# Nationwide Bank Devizes, Maryport St, Wiltshire, SN10 1AH - Stone Replacement Areas At April 2024

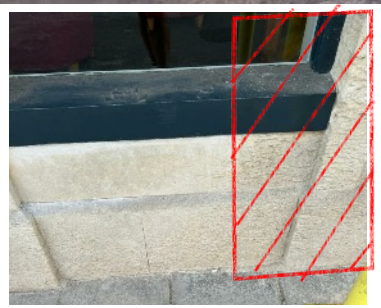
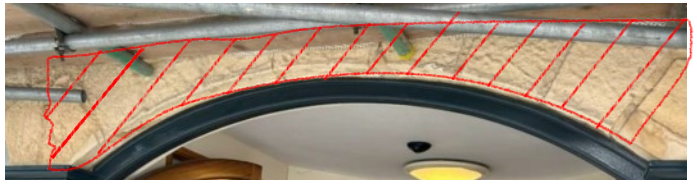
5 - Vertical stone pillar to right hand door entrance structural instability

4 - Vertical stone pillar to left hand door entrance structural instability

2 - Area over entrance door arch to be replaced due to defected sprawling stonework

6 - Bottom plinth area and part column under window to be repaired if possible, if not replaced

1 - Area over ATM window stonework spalling and to be replaced

9/10 - Areas over arch window - stone work to be repaired

8 - Vertical stone defected adjacent neighbouring building on right

7 - Bottom plinth under window with sever erosion to be replaced

3 - Area over entrance doors arch to be replaced due to sprawling stonework
